Technical Bulletin 164

Lamp Getter Movement

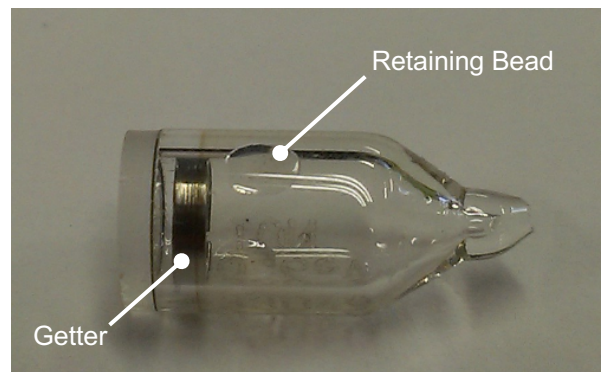
This change ensures that the metallic band within the lamp named the 'getter' remains stationary throughout its life.

Previously it had been noted from customers that the getter could move up and down the length of the lamp. Although testing showed no deleterious effect we listened to the concerns raised and acted accordingly.

The new lamp can be recognized by two transparent beads of glass within the interior of the lamp (see accompanying photo).
